REV	DATE	DESCRIPTION	ISS	REV	DATE	DESCRIPTION	ISS
P1	20/06/17	ISSUES FOR MARKING	MCJ				
P2	03/10/17	ISSUES FOR MARKING - AMENDMENTS	MCJ

CAMDEN GOODS YARD
BLOCK D
SECTION AA
1095_04_07_300
SCALE 1:100 @A0

CAMDEN GOODS YARD
BLOCK D
SECTION BB
1095_04_07_301
 SCALE 1:100 @A0

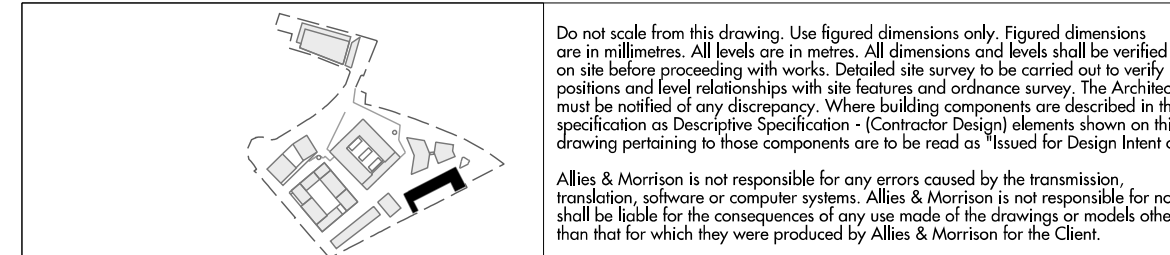
AMENDMENTS:
- canopy above ground floor duplex entrances moved below brick
- planters pushed back to be flush with facade
- brick parapet replaced with balustrade

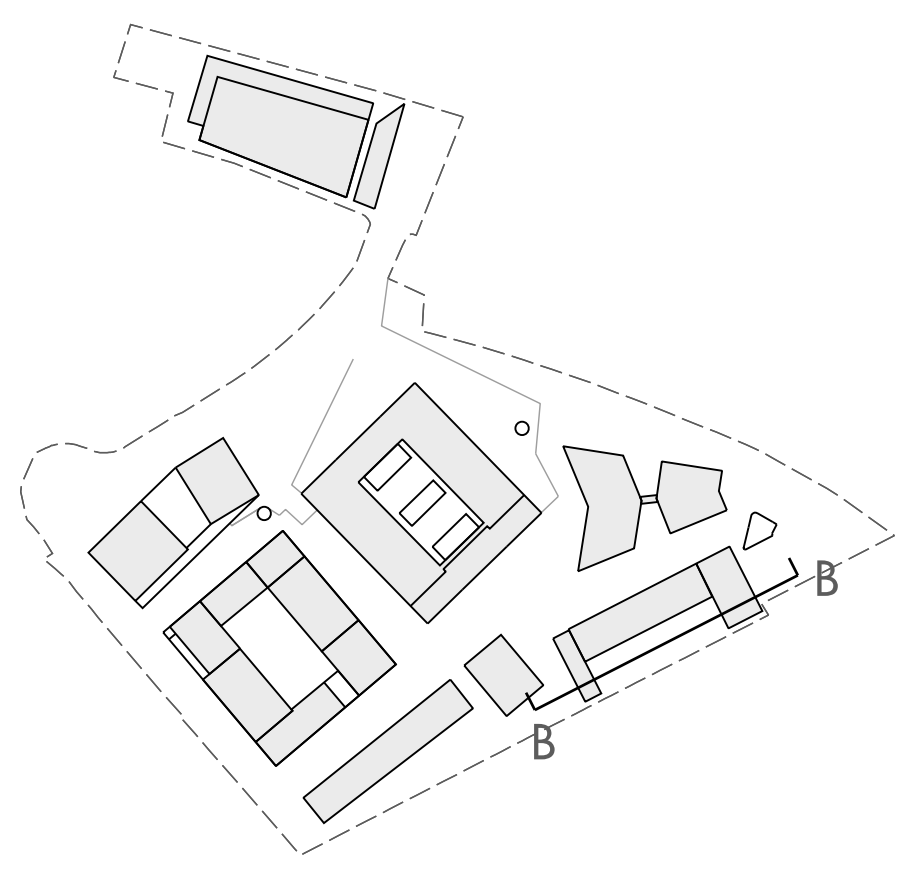
AMENDMENTS:
 - eastern part of building - parapet height reduced and 1m recessed balustrade added
 - retail structure - parapet reduced by 200mm
 - ground floor plant room openings changed
